Oyster Creek Generating Station
Facility Operating License No. DPR-16
NRC Docket No. 50-219

Subject: Response To Request For Additional Information – License Amendment
Request No. 315, “Application of Alternative Source Term” (TAC No. MC6519)

RESPONSE TO REQUEST FOR ADDITIONAL INFORMATION

LICENSE AMENDMENT REQUEST No. 315

Figure 1

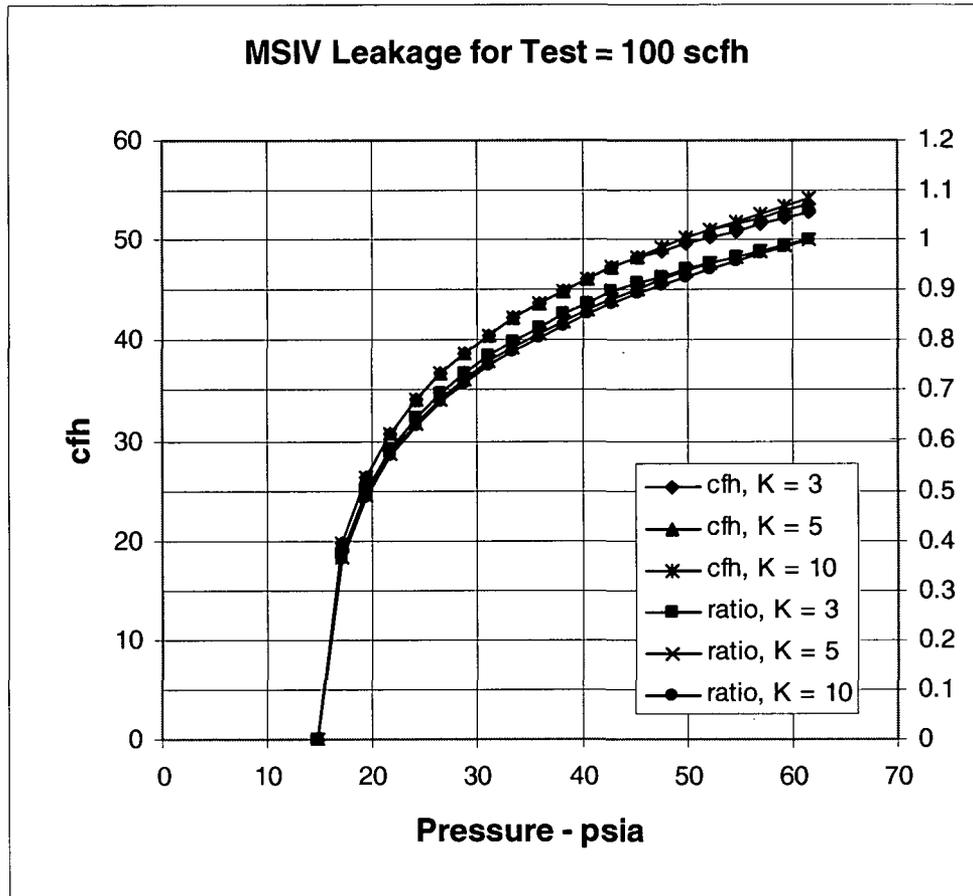
2. RG 1.183 Position 4.5 states that technical specification values should be used. Position 6.2 states a similar position for the main steam isolation valves. Given that secondary bypass leakage rate is calculated as a function of pressure:
 - a. Provide justification that leakage through narrow, ill-defined clearances that may change with pressure, like the stem and seat areas of valves, can be modeled as isentropic nozzles.

It is technically the case that the ratio of accident flow to test flow would be weakly affected by the assumption of a specific flow resistance. This effect is shown in the following study of Main Steam Isolation Valve (MSIV) volumetric flow vs. pressure with resistance as a parameter for a given mass flow at test conditions (100 scfh):

The plotted ratio in Figure 1 (right-hand vertical axis) is that of volumetric flow at 61.6 psia (the peak accident pressure for the case studied – not Oyster Creek) to volumetric flow at a given pressure less than the peak accident pressure. One can see that the ratio is not greatly affected by the assumed head loss coefficient, K; and this observation tends to confirm the assumption that any specific value of assumed flow resistance would not produce ratios of accident flow to test flow greatly different from another. (Note that the head loss coefficient for an isentropic nozzle is effectively zero since all velocity head is recovered. While that case was not specifically included in this study, the trend of the study is clear: lower flow resistances tend to create slightly greater ratios of accident flow to test flow for pressures less than the test pressure. This means that for Oyster Creek, the assumption of an isentropic nozzle tends to result in slightly higher containment leakage rates as the containment pressure decreases than would be the case for $K > 0$. However, in any case, the effect is small.)

The assumption of an isentropic nozzle comes directly from the pre-alternative source term (AST) licensing basis for Oyster Creek, but it is as valid as any other flowpath assumption since the impact of accident conditions vs. test conditions (fluid pressure and temperature) on volumetric leak rate is assessed on a relative basis (not on an absolute basis) as just described.

STARNAUA Spray Droplet Efficiency for 1000 um Droplet Compared to SRP 6.5.2

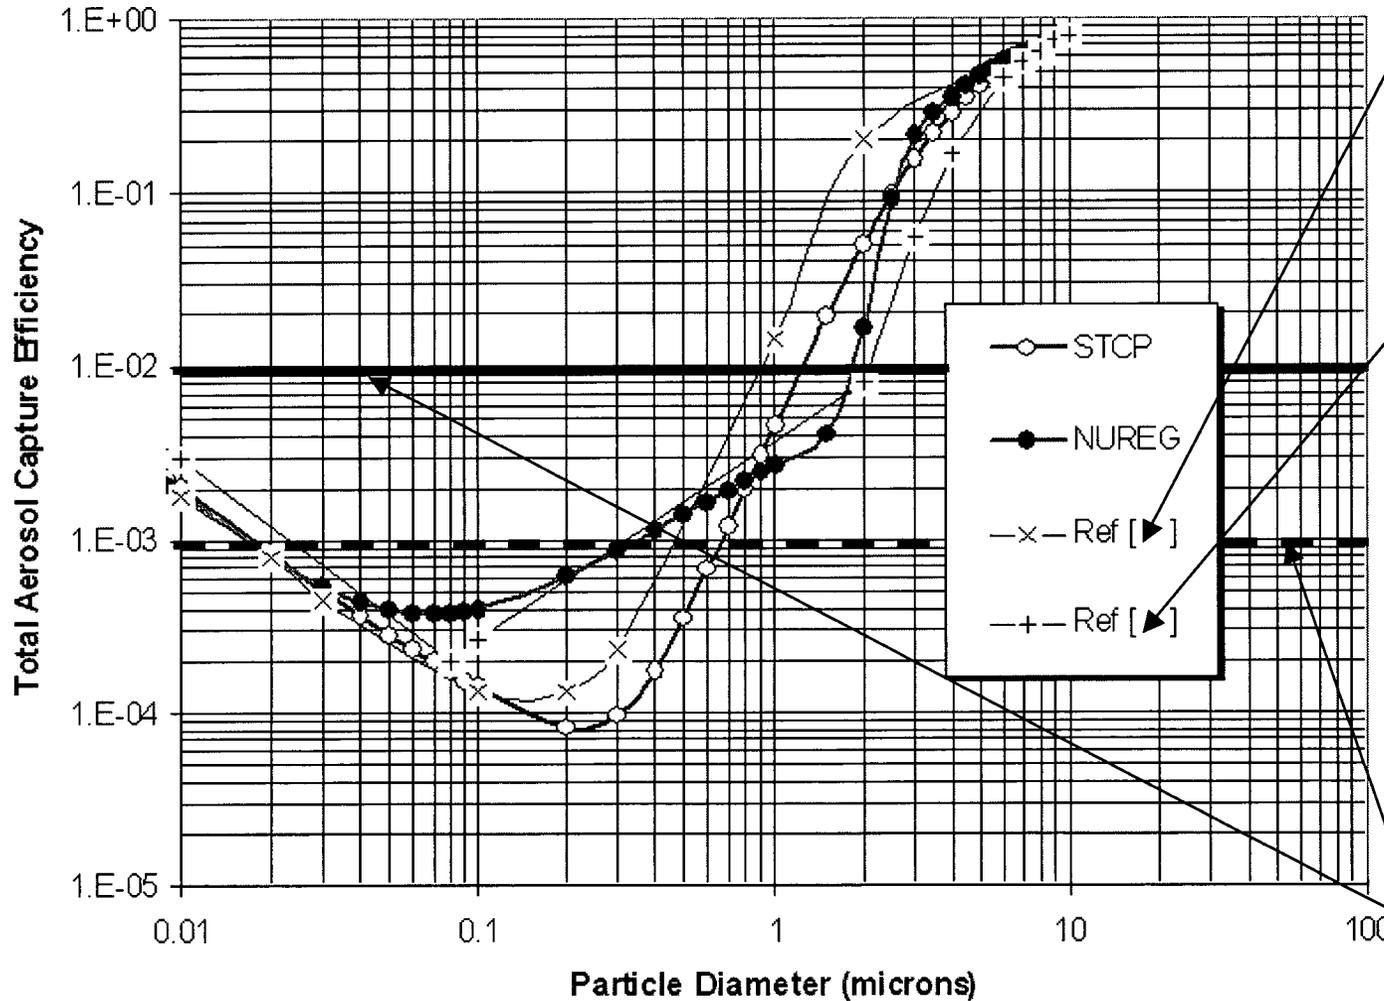
4. With regard to the assumptions for drywell iodine removal:
 - a. Justify the use of the STARNAUA removal models for this application. One way that would be acceptable to the NRC staff would be to compare STARNAUA to the models referred to in RG 1.183 as acceptable spray removal and natural deposition models.

The difference between STARNAUA and SRP 6.5.2 is in the quantification of E/D. As noted above, the E/D is conservatively estimated to be 10 per hour (1% efficiency for a one mm drop) until 98% of the mass has been removed and then one per hour (0.1% efficiency for one mm drop) after that. The removal efficiency calculated rigorously by STARNAUA is similar as seen on Figure 2.

In Figure 2, both STARNAUA modeling options (STCP and NUREG) are presented. The NUREG option is preferred and has been exercised for Oyster Creek. Figure 2 shows the removal efficiency for particles of different sizes. It may be noted that for sub-micron particles, the rigorously calculated removal efficiency may be substantially lower than 1% and even 0.1% (the removal efficiencies used for the SRP 6.5.2 model). The key, therefore, is having an accurate estimate of the size distribution of the airborne particulate.

If the SRP 6.5.2 model were used, the spray lambda for Oyster Creek would be approximately 17 per hour during the release phase. The STARNAUA results vary between 48 per hour (immediately after one of the spray restarts at $t = 68$ minutes) to 16.5 per hour (quasi-steady state at the end of the early in-vessel release phase). During the time the sprays are off, agglomeration tends to increase the airborne particle size so that when sprays are restarted, there is a short-duration surge in removal rate. The "steady-state" removal rates are very similar (SRP vs. STARNAUA), as the diagram below would suggest for particle aerodynamic diameters between one and two microns. Therefore, for Oyster Creek, the best way to characterize the spray removal rates is that they are comparable to those derived from NRC methods, but not as conservative. They are more physical in that when sprays are secured, the growth in the airborne particles by agglomeration is reflected in the brief increase in the removal rate when the sprays are restarted.
